Fairhope Planning Commission Agenda

December 1, 2025 – 5:00 PM

Staff recommends **APPROVAL** of SR 25.06 –Pelc Tire Auto Service Center Site Plan with the following conditions:

Proposed Landscape Plan

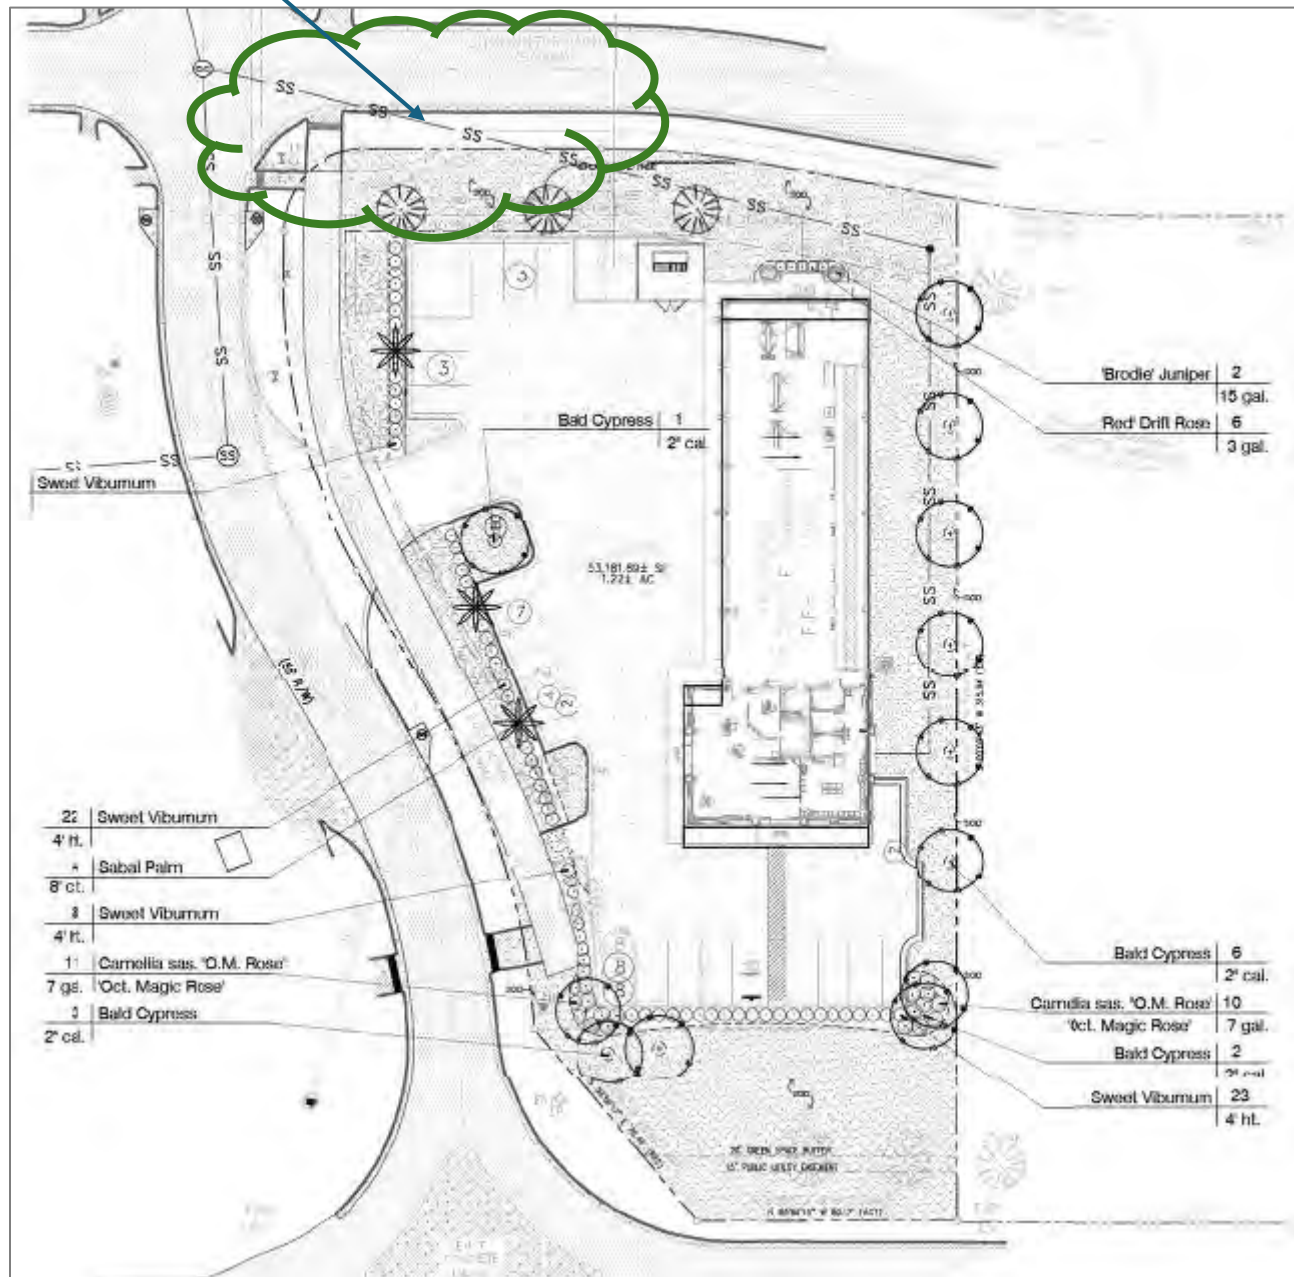
1. Revise landscape plans to add perimeter landscaping on property that is adjacent to Encounter Drive ROW (including screening the dumpster enclosure in that area) per Ordinance #1444 and staff comments; and
2. Revise photometric plan in compliance Article IV, Section B(3) (10' MAX height limit for parking lot lighting).

Add unbroken visual screen of 48" plantings to this area

L1

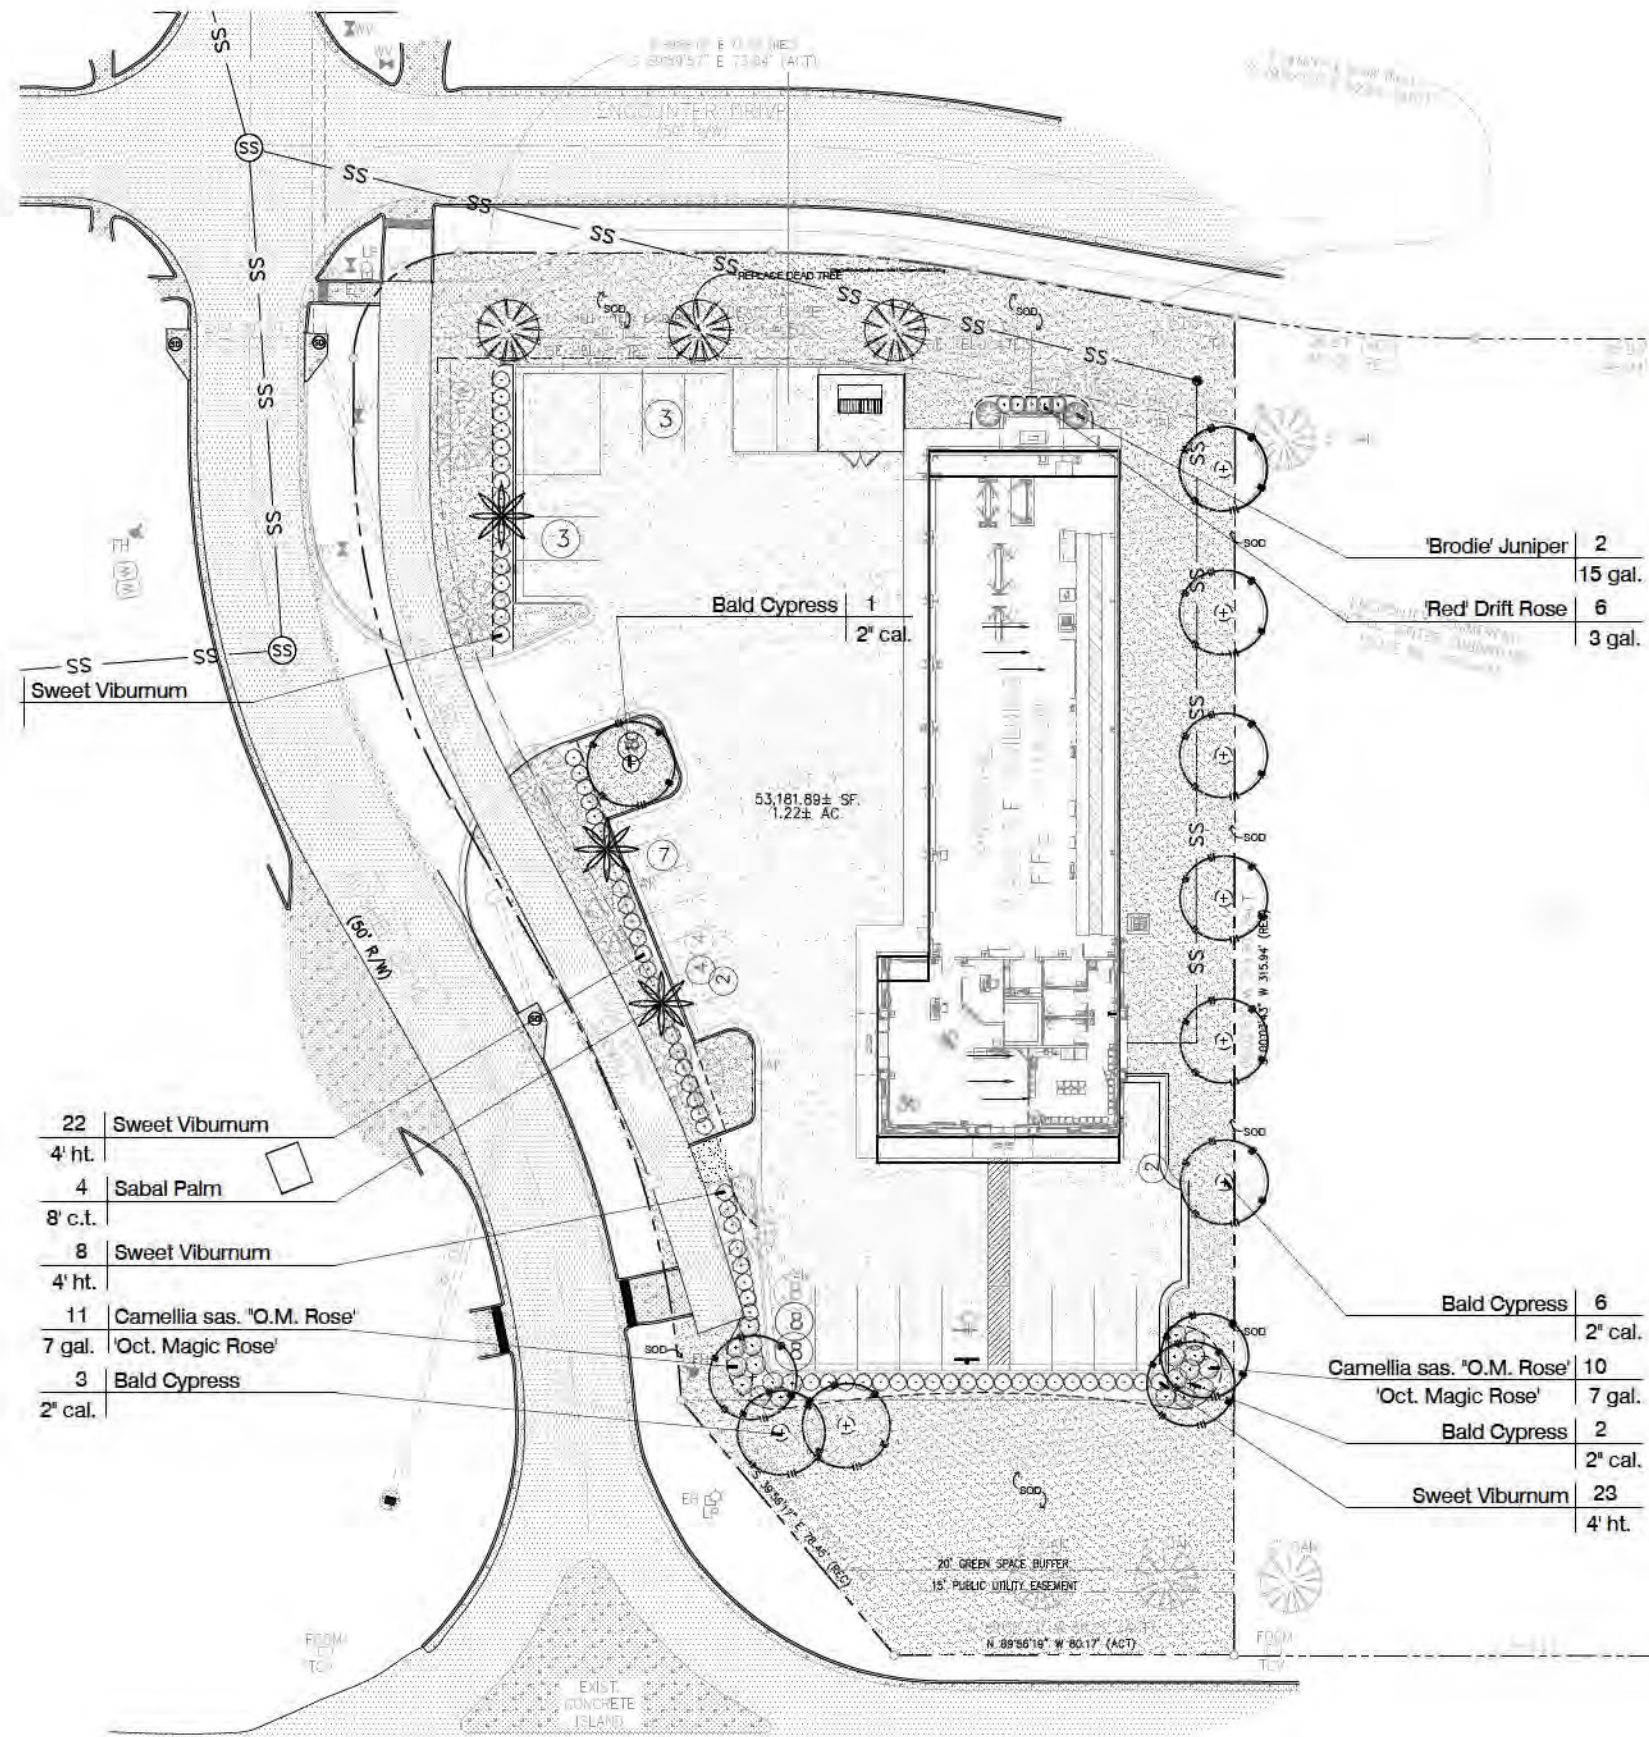
1. Updated landscaping plan per previous comments/requests;
